SUBJECT: NRC STAFF'S PRELIMINARY FINDINGS REGARDING EXELON GENERATION'S (EXELON'S) PROPOSED LICENSING APPROACH FOR THE PEBBLE BED MODULAR REACTOR (PBMR)

Staff Preliminary Assessment of Exelon's Proposed Licensing Approach

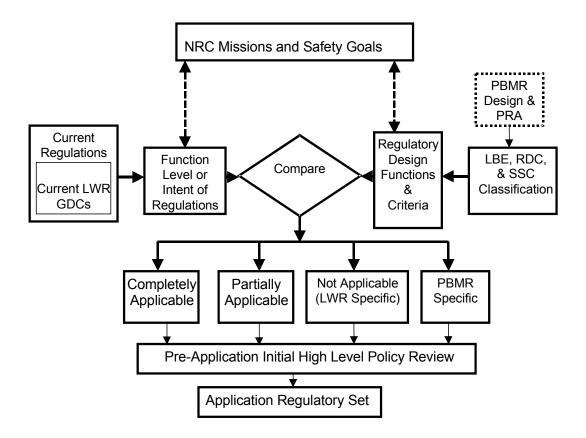
The staff recognizes that this process only addresses the regulatory issues that have been identified as part of the development of LWR regulations. This is why the information represented by the boxes on the top right of Figure 1 concerning regulatory design functions and criteria is needed to fully elicit and identify PBMR-specific issues.

In the absence of design details that are required for a final PRA, the applicant must make assumptions regarding the design and performance of various systems (in consideration of the right-hand side of Figure 1); these assumptions need to be explicitly identified so as to make the applicant accountable for validating them.

Figure 2

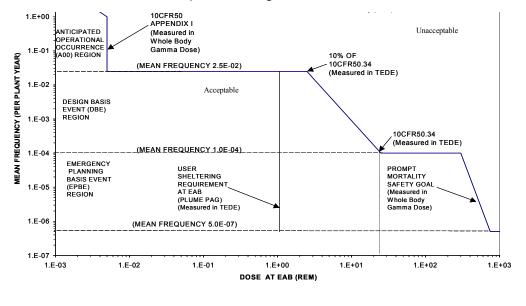
Exelon's proposed licensing approach, as it relates to applicability of NRC regulations, focuses on the safety regulations contained in the current 10 CFR Part 50. Exelon's plotting of the TLRC is consistent with past principles, but poses technical challenges, such as determining the appropriate frequency ranges applicable to each of the regions. The current regulations include a frequency reference for the definition of AOOs, but do not contain a similar reference for DBEs. Exelon has chosen 1 x 10⁻⁴ per plant year as the lower frequency for a DBE. The staff will continue to assess the appropriateness of this value and its consistency with current practice and the criteria contained in SECY-00-198 which discusses RIP 50 Option 3, taking into account such considerations as cumulative effects (for the families of events and for multiple modules) and the frequency ranges considered in other advanced reactor reviews. In the event that such technical questions arise, they might have concomitant policy implications which could require Commission guidance before such guestions can be resolved. Some of these technical and policy issues have been identified in this assessment, but more could arise as the staff's pre-application review proceeds. For example, the TLRC use one of the quantitative health objectives (QHO) from the Commission's safety goal policy (i.e., the risk of prompt fatality); however, the other QHO on latent cancer risk is not addressed. The staff expects continued interactions with Exelon to help clarify some issues.

The staff notes that plotting of TLRC is useful to illustrate bounding criteria and safety margins. However, the licensing basis is the set of requirements that are applied to the safety-related equipment to meet the LBEs (or other special regulatory objectives such as anticipated transients without scram (ATWS) or station black-out (SBO)); simply falling within the plot of the TLRC does not in itself constitute a complete licensing basis. Moreover, while the PRA confirms risk insights for a design, and can be used for other purposes as noted above, licensing activities will be a mix of "deterministic" analysis supplemented with risk insights. The lack of operational data for some of the unique PBMR SSCs makes complete reliance on PRA difficult.

Figure 3 Radionuclide Retention Functions for the MHTGR

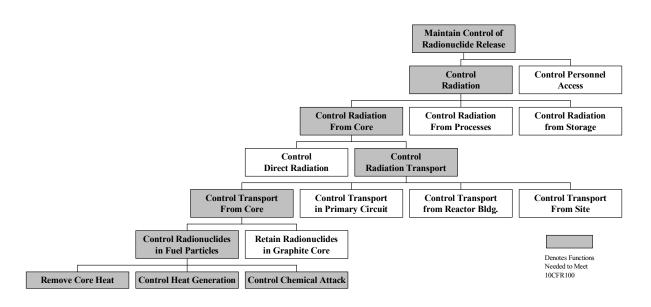
While the staff understands that this is not a PBMR-specific figure, the figure seems to imply that the function can be met without controlling radionuclide transport from the reactor building and from the site, which appears to contradict the defense-in-depth philosophy. The role of a containment in the PBMR design will be specifically addressed and is expected to be presented to the Commission as a policy issue. The staff believes that system redundancy, defense-in-depth, and maintenance of safety margins should be incorporated into the process for categorizing SSCs as safety-related. The staff will continue to discuss these concerns with Exelon in its pre-application review.
